Proposal for amendments to Regulation No. 110 (CNG Submitted by the expert from Italy

Informal document GRSG-114-32
(114th GRSG, 9-13 April 2018
agenda item 6.(b))

Four points related to CNG4 cylinders with shoulder pads but with very different aims

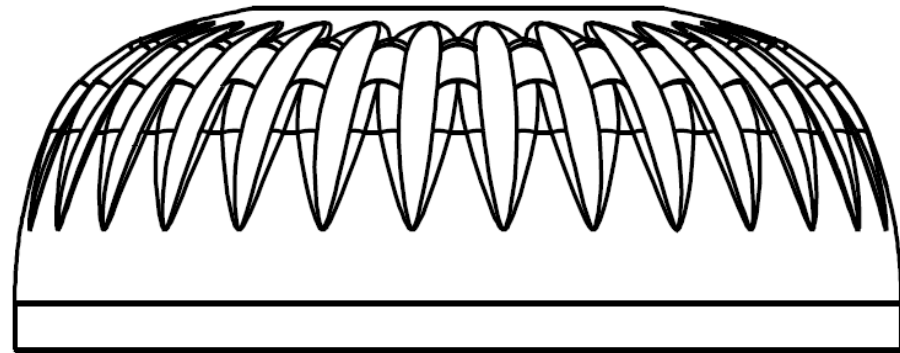
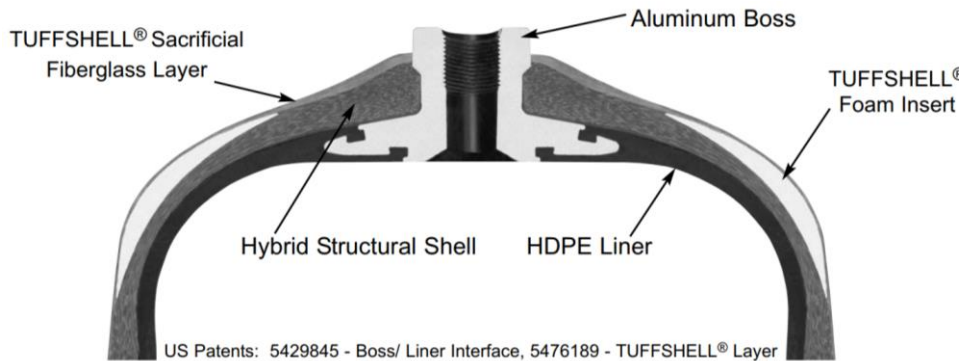
- IN ALL CASES THE FAILURES OCCURRED ON A ZONE OF THE DOME ENDS UNDER THE SHOULDER PADS WHERE THE THICKNESS IS ABOUT ONE HALF OF THAT IN THE CYLINDRICAL PART

- AFTER A CHANGE OF DESIGN (RULED BY TAB. 6.7 OF ANNEX 3) IT IS POSSIBLE TO HAVE R110 APPROVED CNG4 CYLINDERS THAT DO NOT GUARANTEE THE REQUIRED STRENGTH AGAINST IMPACT DAMAGE.
- SHOULDER PADS (OR DOME COVER PROTECTIONS) ARE NOT MENTIONED IN ANY POINT OF R110. THEIR USE IS NOT RULED IN ANY WAY AND THEY ARE NOT CONSIDERED, IN TABLE 6.7, FOR A CHANGE OF DESIGN.

- A) To explicitly introduce the dome end protective covers in R110, ruling their use and specifying the tests to be performed in case of their change of design.
- B) To explicitly say that the R110 required reliability to impact damage shall be given by the CNG4 cylinder itself, and not by glued shoulder pads.

the Italian proposal has chosen the second solution, most unpopular since it is against some today adopted constructions?

the first solution, although it could consent to fulfil what required by paragraph A.20, it will also reduce the reliability of the cylinders, since it will allow to accept a lower strength of their weakest point, which is also the most exposed to defects of production.
